NAVIGATION - TRANSMITTAL OF COLLINS AEROSPACE SERVICE BULLETIN ATL-4000-34-D,
NAVIGATION - ALT-4000 - EVALUATION OF SURFACE MOUNT FERRITE BEAD USED ON THE POWER
SUPPLY

MTL-34-03
Page 1 of 3

SUBJECT: NAVIGATION - ALT-4000 - EVALUATION OF SURFACE MOUNT FERRITE BEAD USED ON THE POWER SUPPLY (SUPERSEDES ALT-4000-34-C, 523-0831894)

Power Supply Circuit Card A2A4, CPN 828-2633-007, Component Location Diagram
Figure 1

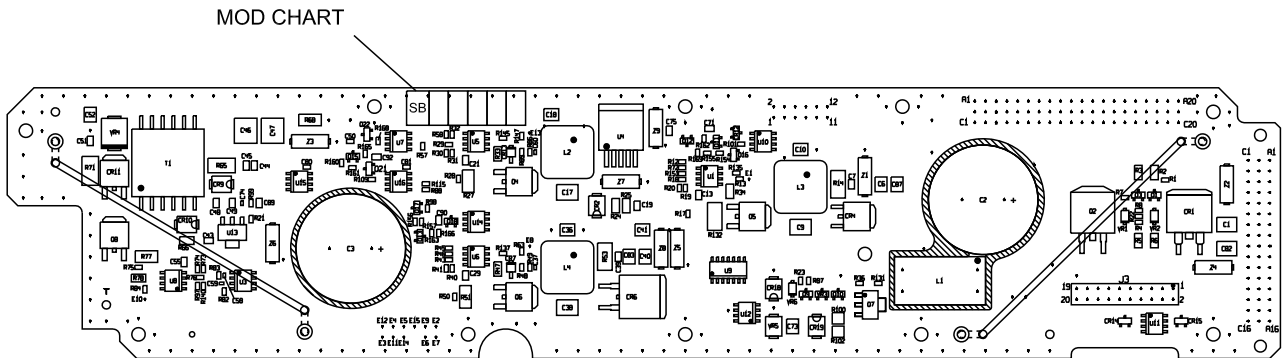
- (1) Remove outer cover from the unit. Retain both the cover and the screws removed from the cover.
 - (a) Locate, remove, discard, and replace surface mount ferrite bead A2A4Z1 and A2A4Z7, CPN 852-3002-030, on the Power Supply Circuit Card A2A4, CPN 828-2633-007. Refer to Figure 1.

- a. Power OFF the UUT using the respective ALT-1000 or ALT-4000 Test Panel.
- b. Replace ferrite bead A2A4 Z1 and Z7 CPN 852-3002-030 on the Power Supply Circuit Card Assembly 828-2633-007.
 - Refer to Figure 1 for the location of Z1 and Z7.
- c. On completion of bead replacement repeat test starting with Step 3.A.(4)(b)5..
